STAFF'S  
REQUEST ANALYSIS  
AND  
RECOMMENDATION

04PR0322

NRP Group, L.L.C.  
(Grand Oaks Apartments – Phase II)

REQUEST: Site plan approval.

Job No.  
**21369**  
Shift No.  
**C5.0**

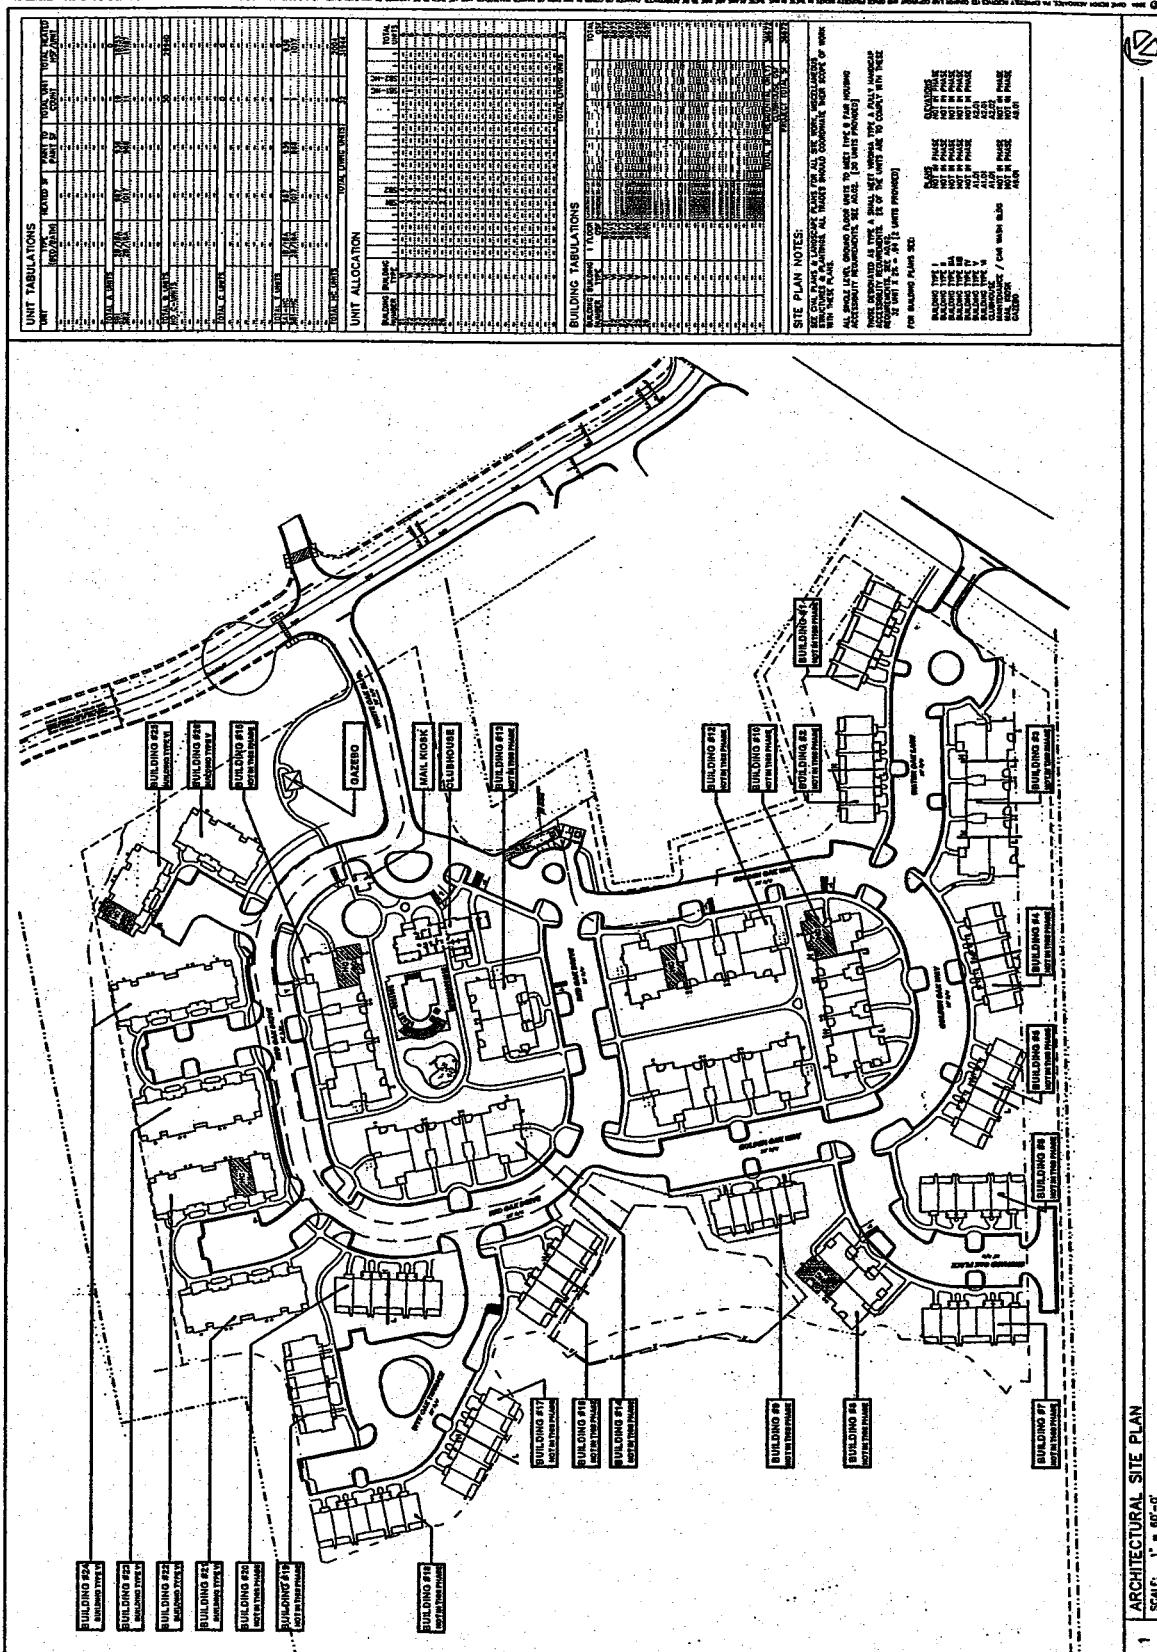
19. Provide top of wall/bottom of wall elevations for the proposed retaining wall on Sheet C5.0. (EE)
20. Pedestrian safety measures must be provided for the proposed retaining wall. Revise the retaining wall detail accordingly. (EE)

21. Revise the proposed DI-1's to DI-7's with pedestrian safe grates in the storm sewer schedule on Sheet C5.0. (EE)
22. All roof water and downdrains must be collected and discharged in a non-erodible manner. Address for Buildings 23, 24 and 25 on Sheet C5.0. (EE)
